## **Certificate of Appropriateness**

2212 E. Kenilworth Pl. North Point South

PTS ID 114845 COA, roof replacement and masonry repairs

Current condition of the property Front (southwest) Elevation

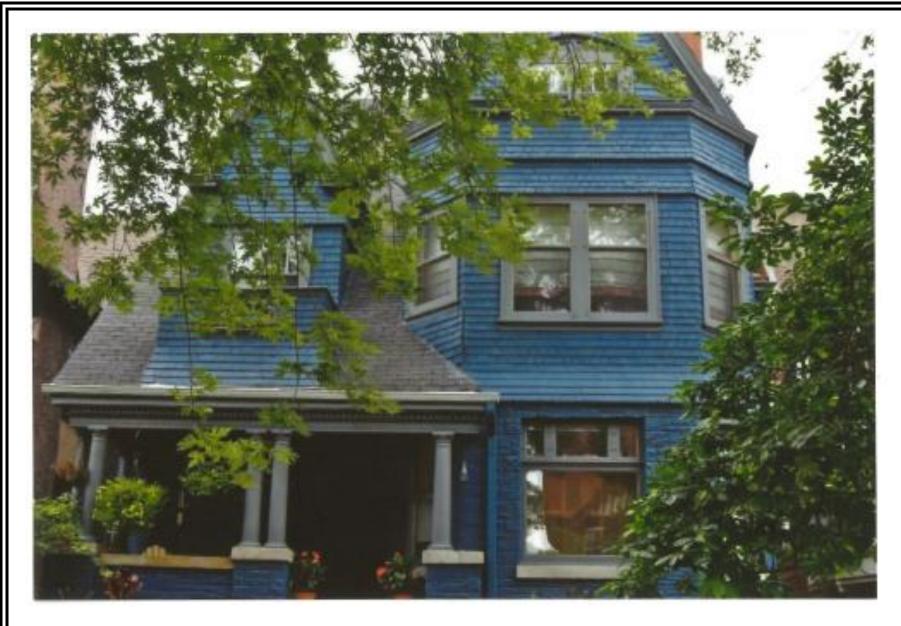
Where flat roofs meet walls (indicated above) siding must be cut out and replaced with cedar siding painted to match existing conditions
